REQUEST FOR PROPOSAL

Project Title: Cooley Lab Renovation
Location: Montana State University

PPA No.: 10-0023
RFP No. 1
Date: 7-19-2011

COOLEY- LEWIS CONNECTING CORRIDOR - ROOF  
CRV 7-19-2011

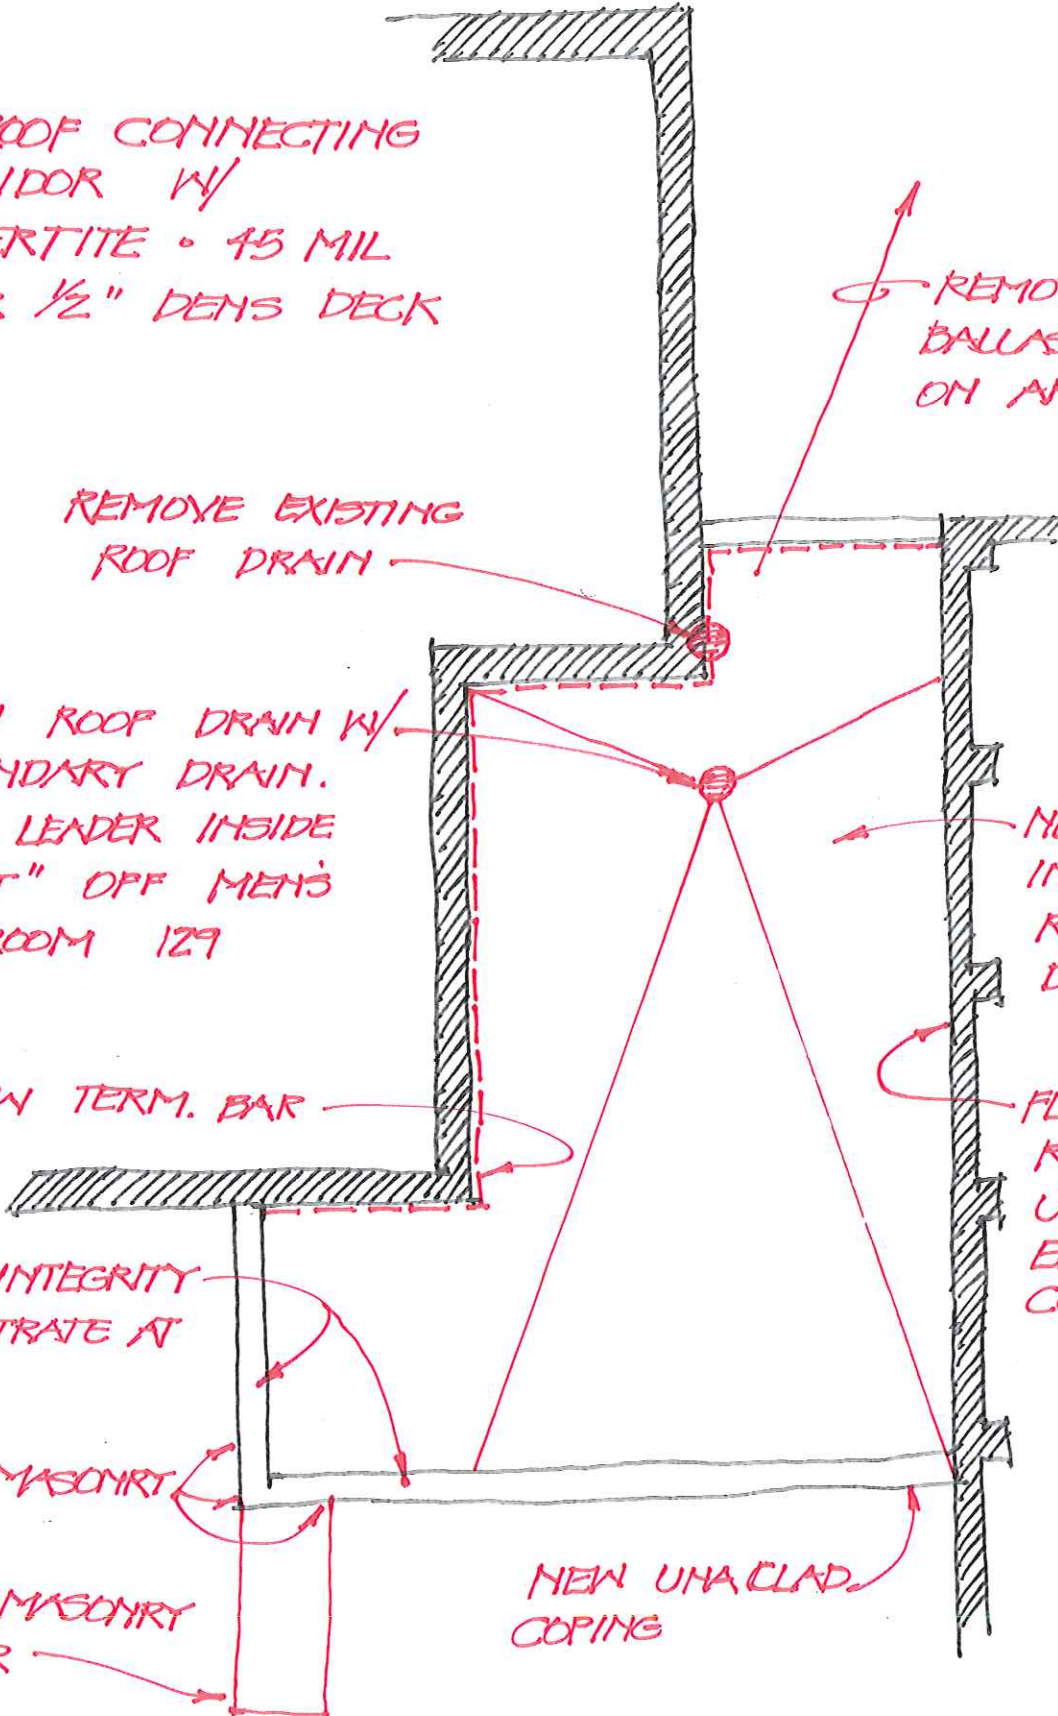
Please provide proposal for re-roofing the connecting corridor between Cooley and Lewis. See attached drawings. Also include the brick repair at the masonry pier into the west entrance of Cooley.

RE ROOF CONNECTING  
CORRIDOR W/  
FIBERTITE • 45 MIL  
OVER 1/2" DENS DECK

REMOVE ROCK  
BALLAST & PUT  
ON ARC ROOF

REMOVE EXISTING  
ROOF DRAIN

NEW ROOF DRAIN W/  
SECONDARY DRAIN.  
RUN LEADER INSIDE  
"CLOSET" OFF MEN'S  
RESTROOM 129

NEW TAPERED  
INSULATION  
R-38 AT  
DRAIN

NEW TERM. BAR

FLASH  
ROOFING  
UNDER  
EXISTING  
COPPER

VERIFY INTEGRITY  
OF SUBSTRATE AT  
PARAPET

COOLEY - 1ST FLOOR  
CRY 7-19-2011

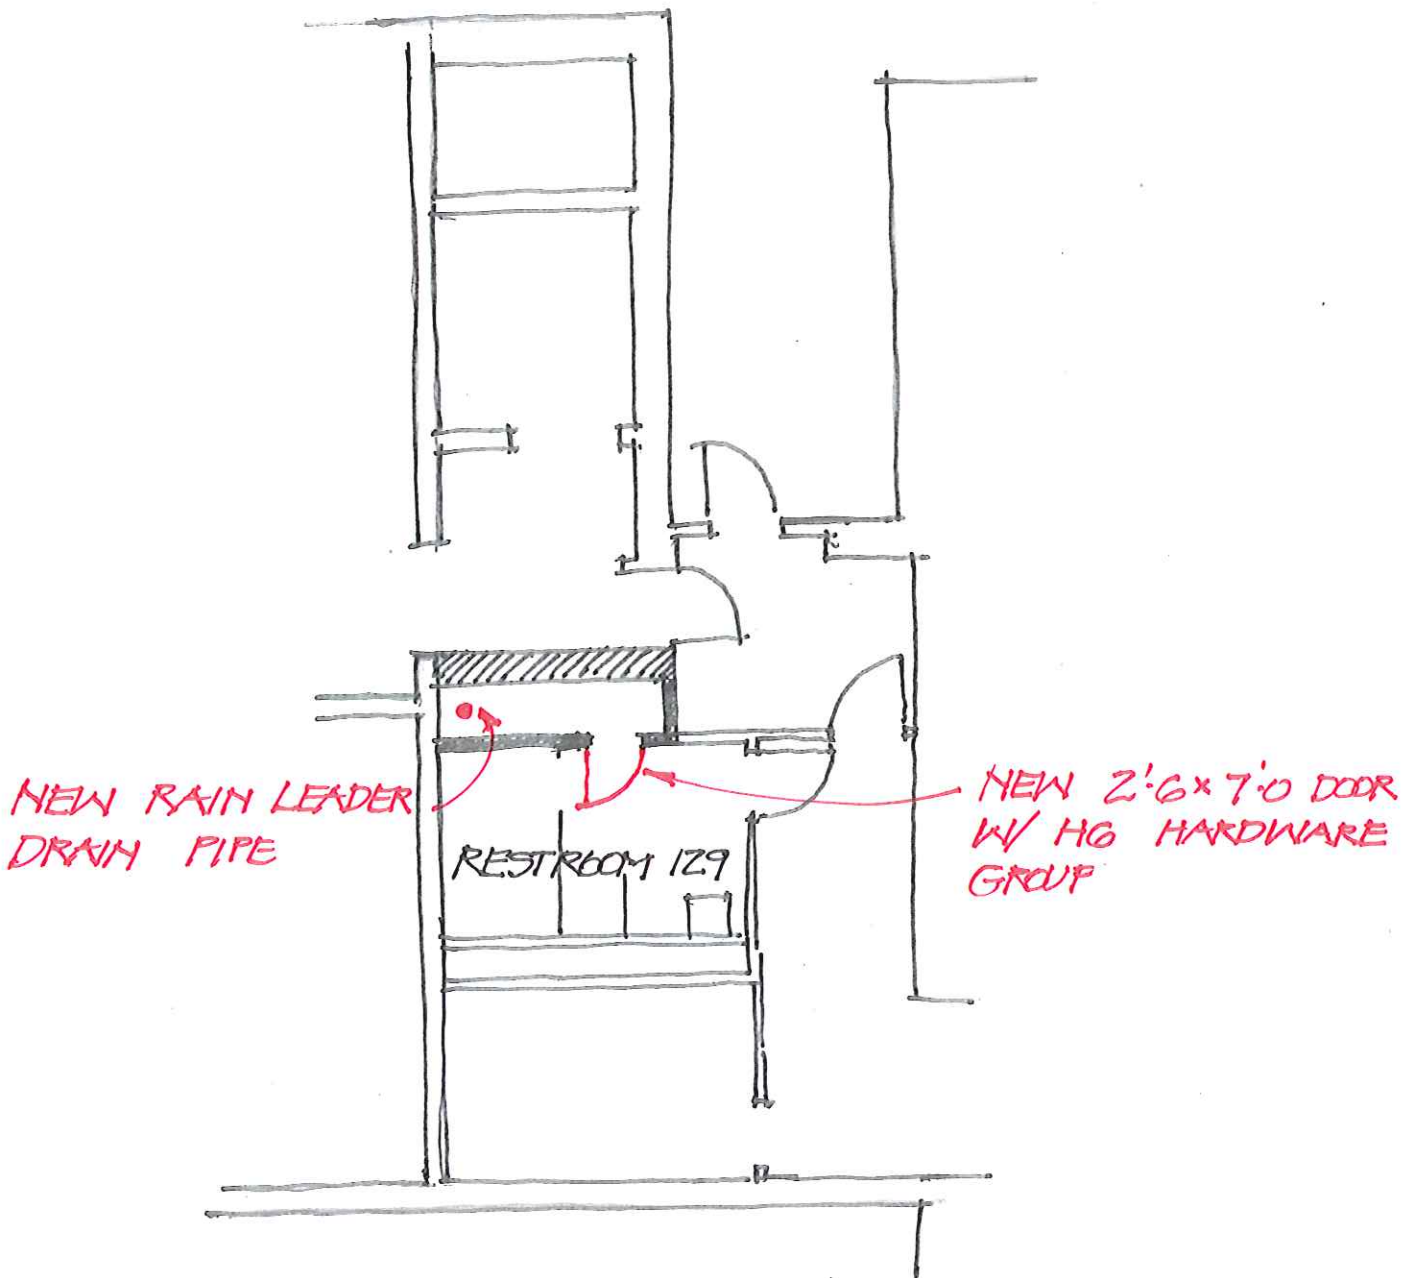
REPAIR MASONRY

REPAIR MASONRY  
AT PIER

NEW UNCLAD  
COPING
